**MINERALS PROGRAM INSPECTION REPORT****PHONE: (303) 866-3567**

<b>MINE NAME:</b> Cresson Project	<b>MINE/PROSPECTING ID#:</b> M-1980-244	<b>MINERAL:</b> Gold	<b>COUNTY:</b> Teller
<b>INSPECTION TYPE:</b> Monitoring	<b>INSPECTOR(S):</b> Patrick Lennberg	<b>INSP. DATE:</b> June 24, 2019	<b>INSP. TIME:</b> 08:30
<b>OPERATOR:</b> Cripple Creek & Victor Gold Mining Company	<b>OPERATOR REPRESENTATIVE:</b> Justin Bills	<b>TYPE OF OPERATION:</b> 112d-3 - Designated Mining Operation

**Photo 13:** AGVLF 10,400' level, typical ponding observed

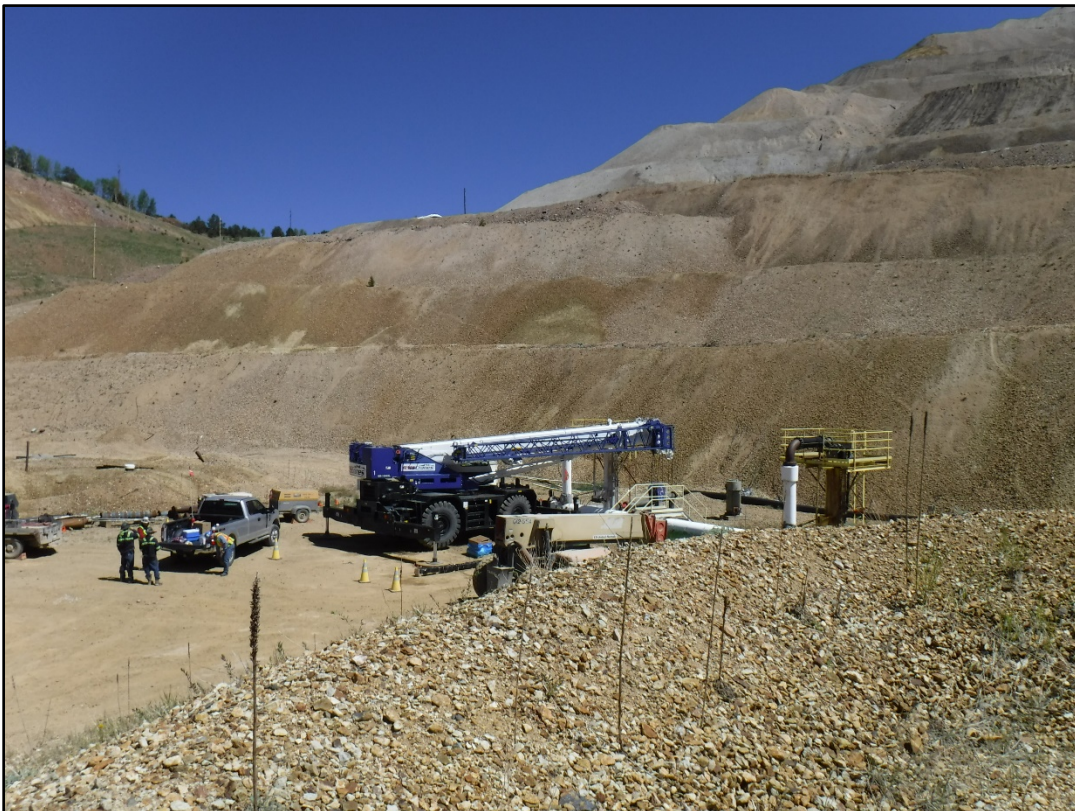
**PROBLEM:** A significant volume of process solution was ponded in the Arequa Gulch Valley Leach Facility. This is a potential attractant to wildlife. The surface area of the exposed fluid exceeded the permit condition (not to exceed 3 feet x 3 feet area).

The current and maximum elevation of ore placement in the AGVLF is 10,400 feet (for Phase V). The Division inspected active leaching surfaces on the AGVLF. These surfaces were well saturated and ponding of leachate, greater than 3 feet by 3 feet, was common. In addition, ponding of leachate was observed on the lower 10,200 foot level, although not as common as was observed on the upper level. During the close-out meeting the Operator indicated that the application rate of leachate had been reduced by approximately 120 gpm in these areas. Also, a crew that was observed on the 10,200 foot level was moved to the upper level to begin ripping the material to promote infiltration. While the weather in the recent past had been wet this was not a significant factor in the ponding. Finally, during an aerial inspection in early June there were several areas of ponding noted including the areas observed during this inspection. A problem is being cited in this report due

to the ponding observed in excess of the 3 foot by 3 foot requirement.

**CORRECTIVE ACTIONS:** Provide the Division with photographic evidence that measures were taken to allow the solution within this area to infiltrate into the pad or other wildlife mitigation measures have been employed by the corrective action date.
